City of Detroit
Inter-Departmental Communication

RE: **Petition No. 1821-revised**
Request to Outright Vacate Various Streets And Alleys And Encroachment Into
Monroe And A Portion Of Cadillac Square In The Area Bound By Monroe,
Randolph, Bates, And Cadillac Square

NOTICE OF PROPOSED CHANGE IN PROPERTY

REQUEST TO OUTRIGHT VACATE AND
 CONVERSION TO EASEMENT
 VARIOUS PUBLIC STREETS AND ALLEYS AND
 REQUEST ENCROACHMENTS OF
 MONROE AVE, A PORTION OF BATES ST. AND CADILLAC SQ.
 IN THE AREA BOUND BY
 MONROE AVE, RANDOLPH AND BATES ST.
 AND CADILLAC SQUARE

DRWG. NO. X 1821

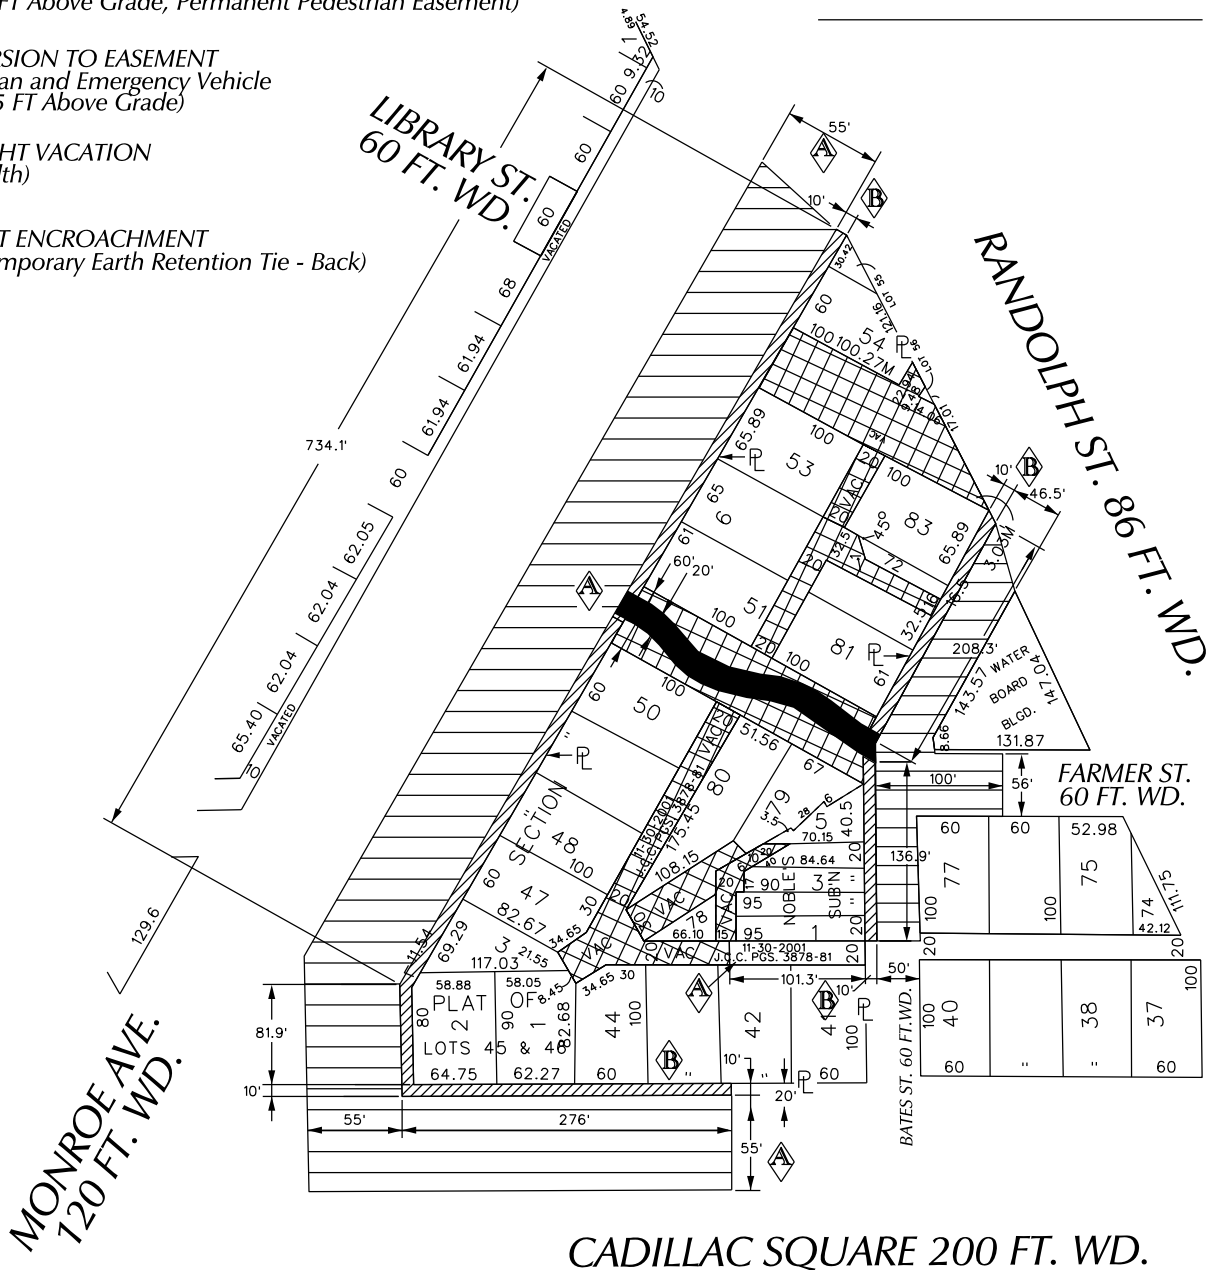
B	CHANGE FROM OUTRIGHT VACATION TO CONVERSION TO EASEMENT	WLW	KSM	KSM	9/28/18
A	REDUCING THE TEMPORARY EARTH RETENTION TIE BACK, REMOVE THE REQUEST TO VACATE ALLEY AND REMOVE THE UNDERGROUND RAMP AND TUNNEL	WLW	KSM	KSM	7/27/18
	DESCRIPTION	DRWN	CHKD	APPD	DATE
REVISIONS					
DRAWN BY	WLW	CHECKED		KSM	
DATE	04-03-18	APPROVED

JOB NO. 01-01
 DRWG. NO. X 1821

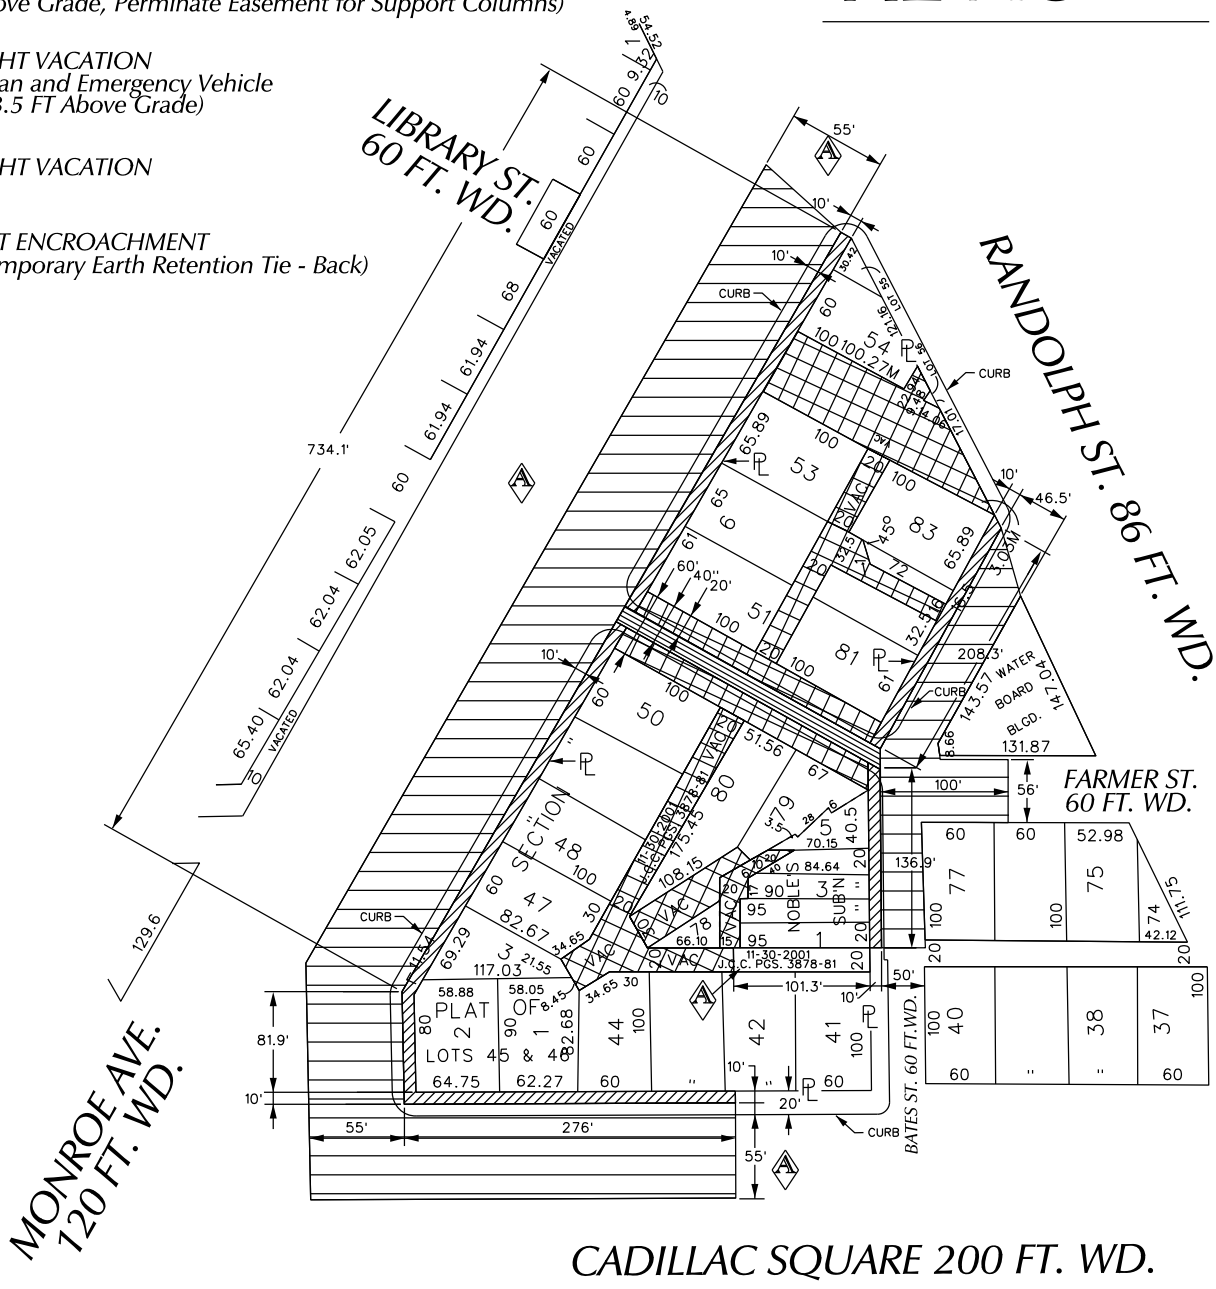
B					
A	REDUCING THE TEMPORARY EARTH RETENTION TIE BACK REMOVE THE REQUEST TO VACATE ALLEY AND REMOVE THE UNDERGROUND RAMP AND TUNNEL	WLW	KSM	KSM	7/27/18
REVISIONS					
DESCRIPTION	DRWN	CHKD	APPD	DATE	
DRAWN BY WLW	CHECKED KSM				
DATE 04-03-18	APPROVED

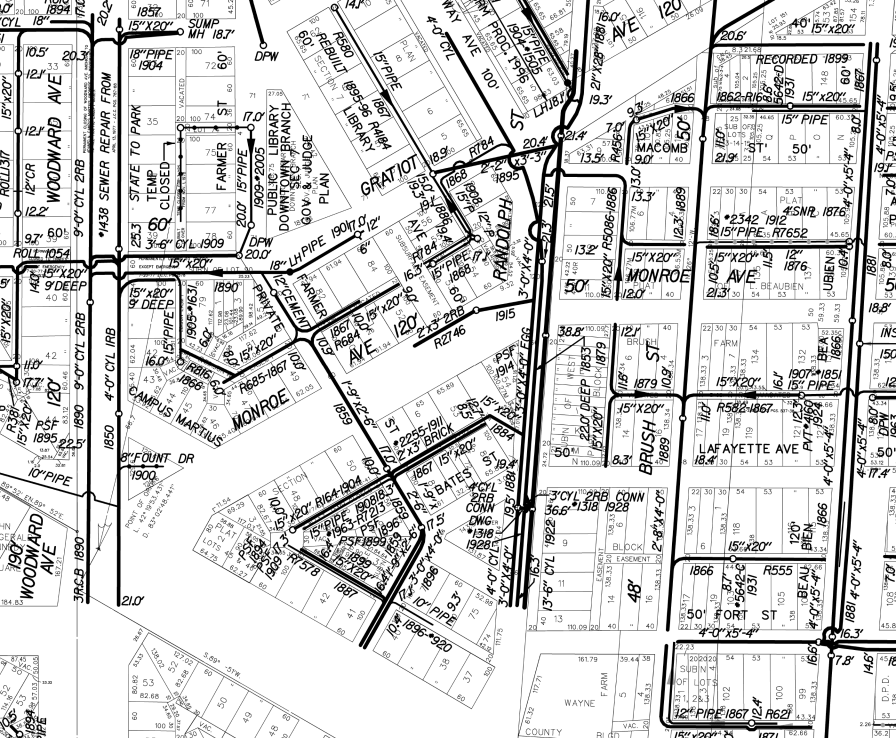
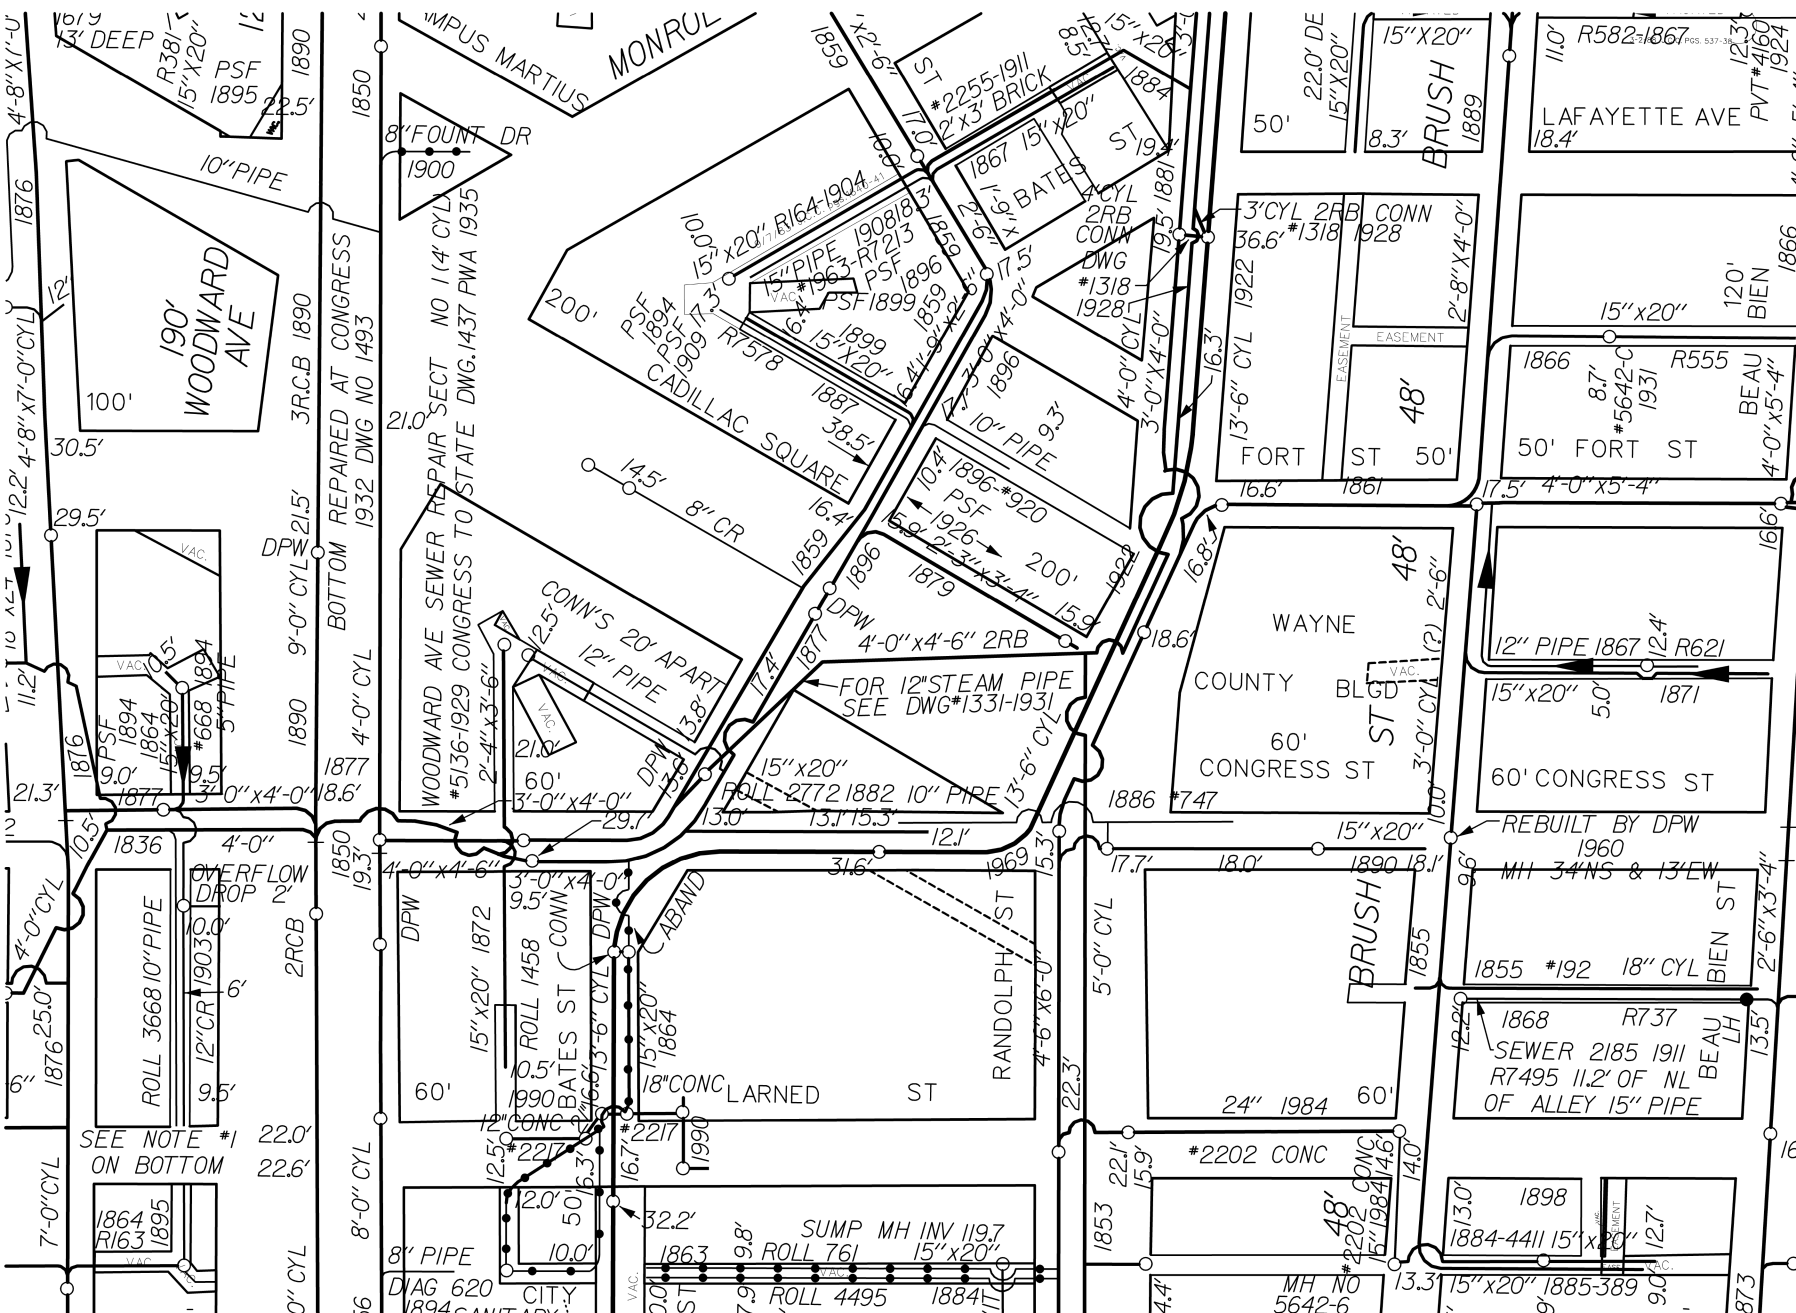
- Remove the proposed underground Monroe ramp and tunnel.
- Remove the request to vacate and retaining the utility easement for the section of the alley behind the Cadillac Tower, this will remain public right-of-way.
- Reduce the temporary earth retention tie back encroachment extents from 100 feet to between 55 feet and 46.5 feet.

PETITION 1821
 MONROE BLOCK VACATIONS
 REVISED 1/31/2018

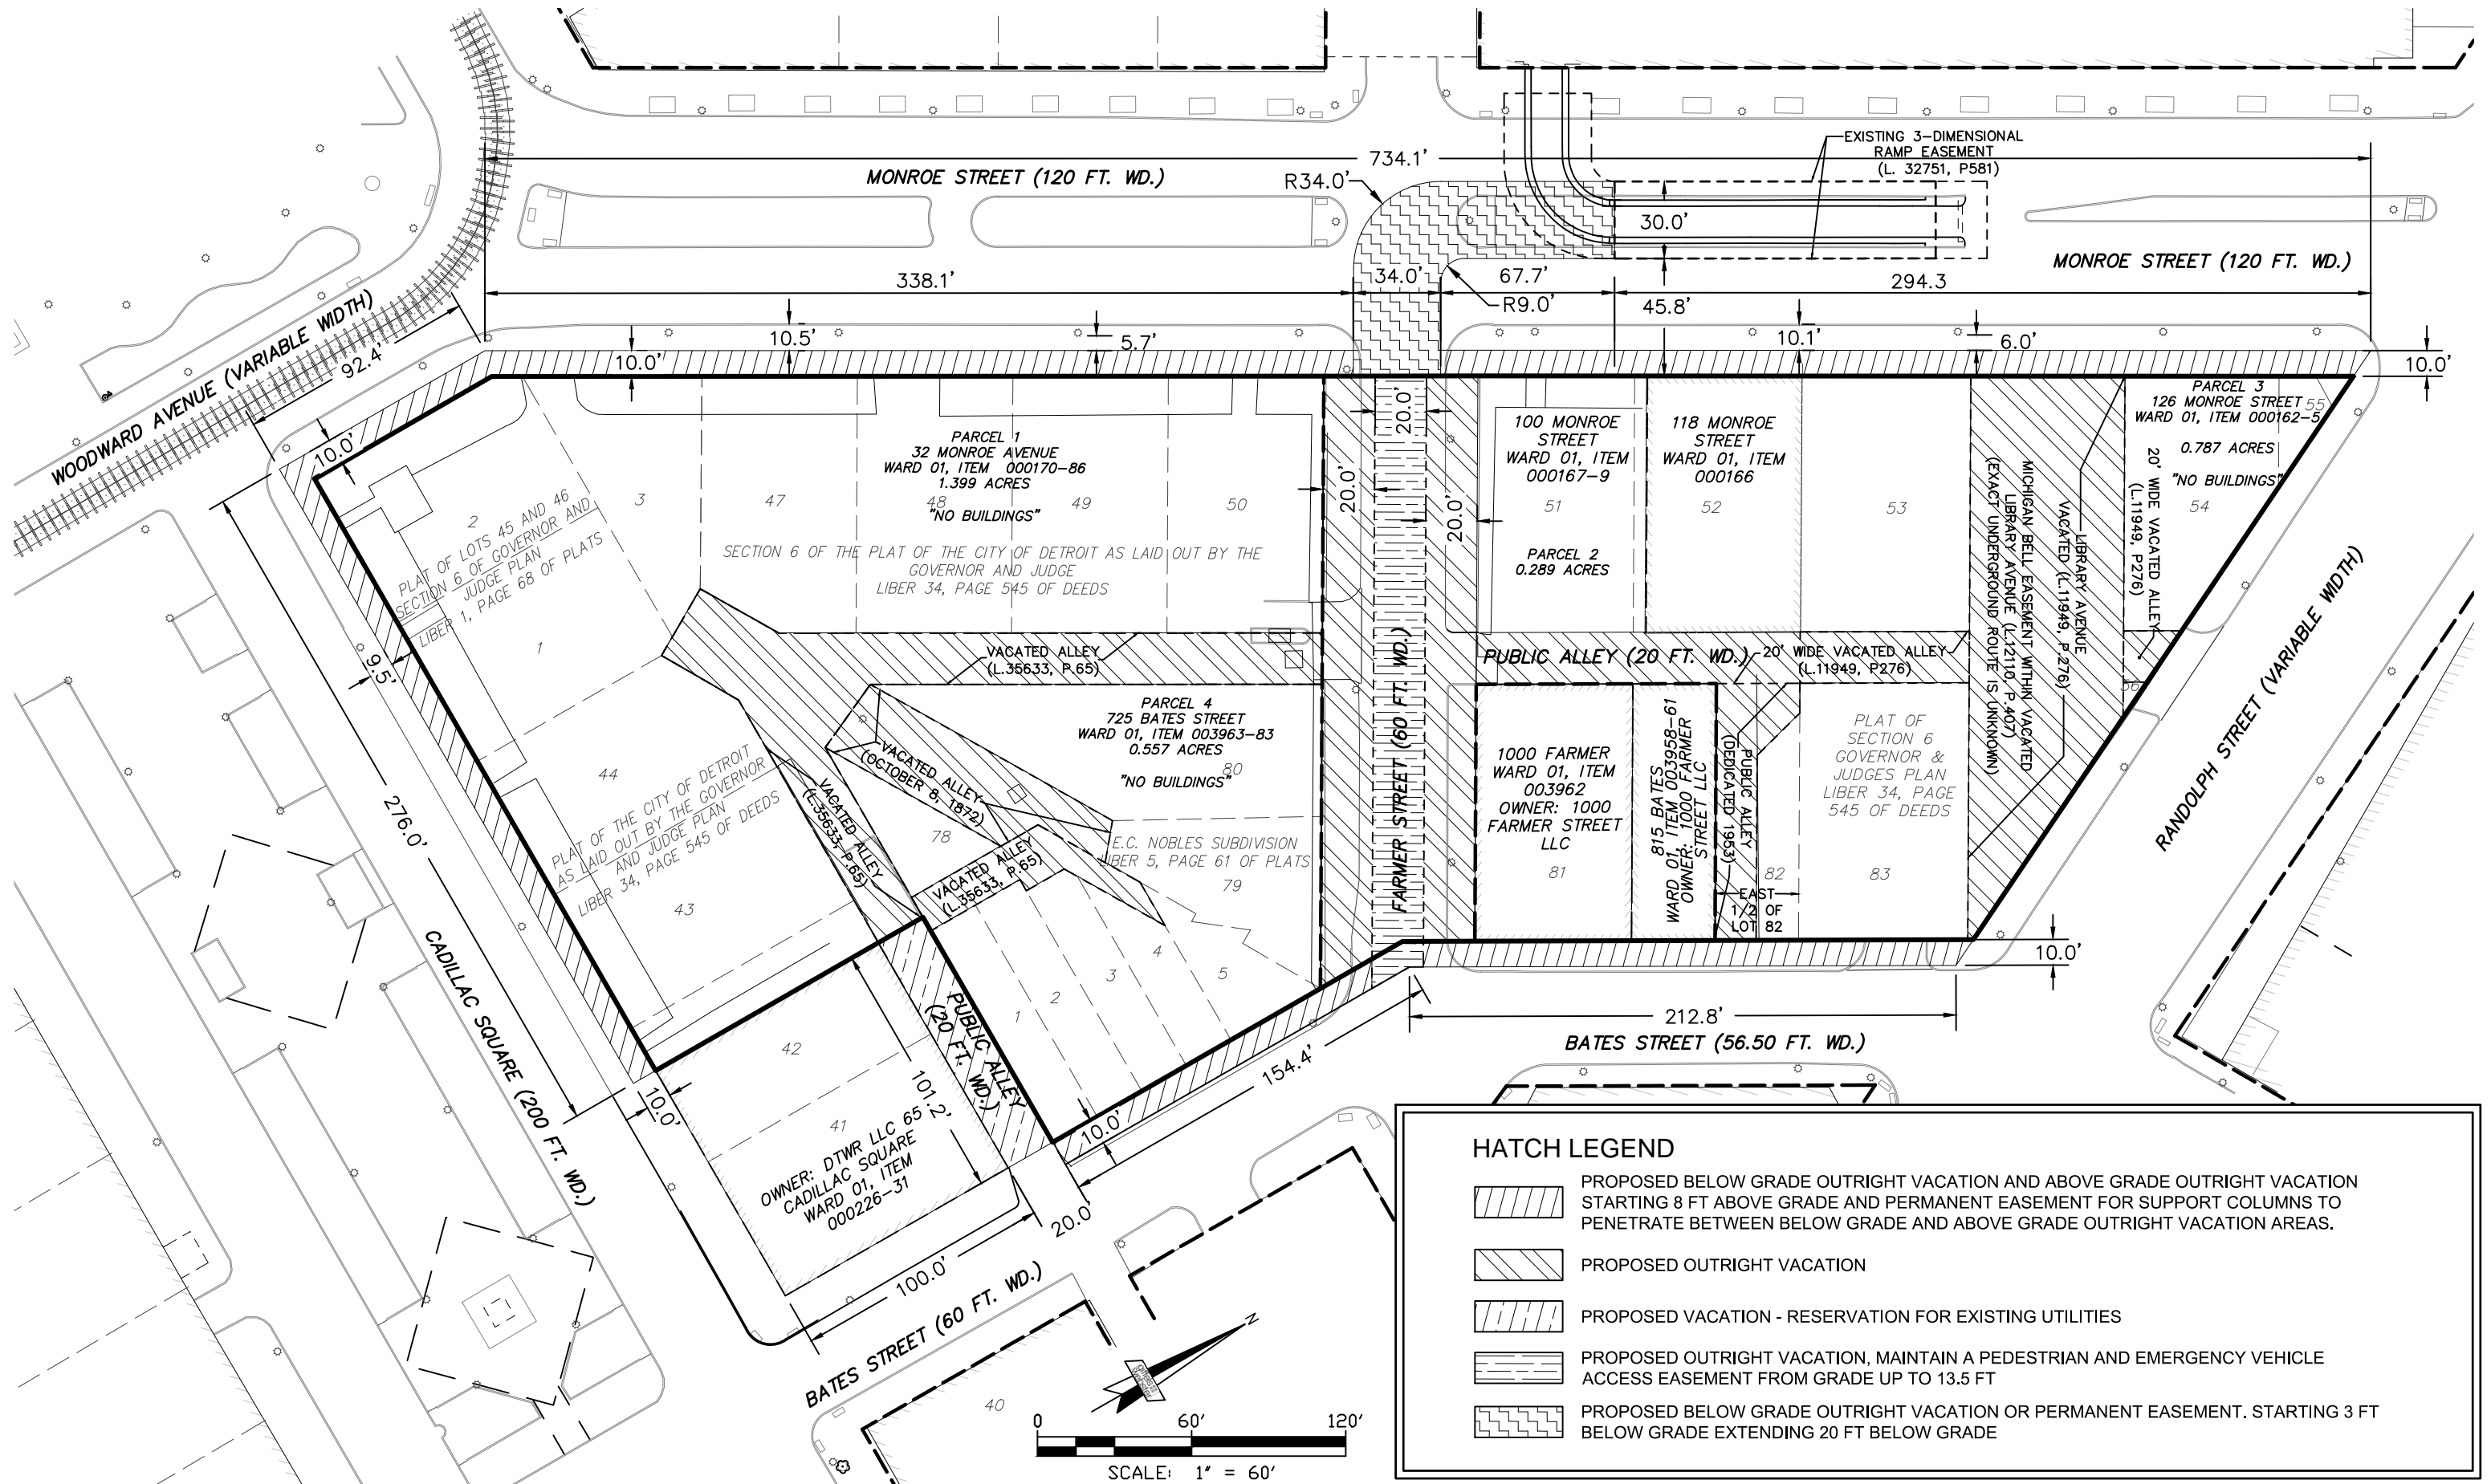
Page1: The revised configuration of the Monroe ramp/tunnel encroachment to line up with Farmer
